## SERVICE BULLETIN

**NUMBER:** 15-211-17R

**REVISED:** 06/26/19

**SUBJECT:** Reprogramming File Availability for Additional Optimization of Harman Gen 3 Audio and Navigation Head Units

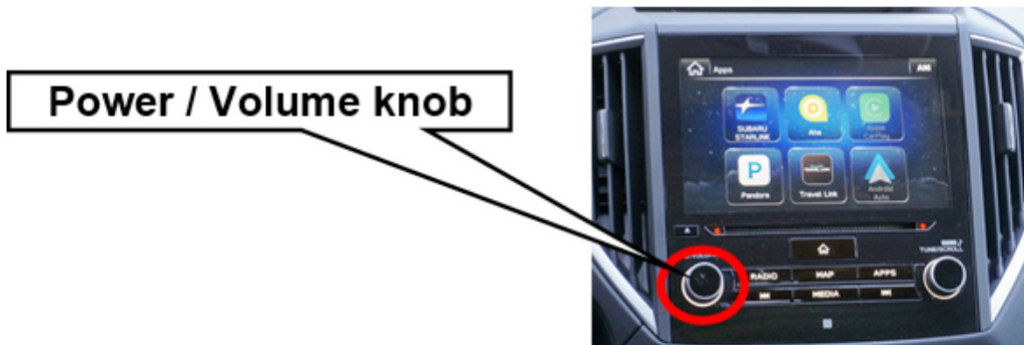
- Operation of the head unit after switching the ignition off and back on has been revised:

**PREVIOUS Version:** The head unit power is turned OFF by pressing the Power/Volume knob for 4 or more seconds. On the next ignition ON, the display remains OFF / black while the audio begins playing automatically. This was the prior characteristic operation.

**NEW Version:** The head unit power is turned OFF by pressing the Power/Volume knob for 4 or more seconds. On the next ignition ON, the display remains OFF / black and the audio will also be OFF until the Power/Volume knob is pressed to turn the head unit back ON.
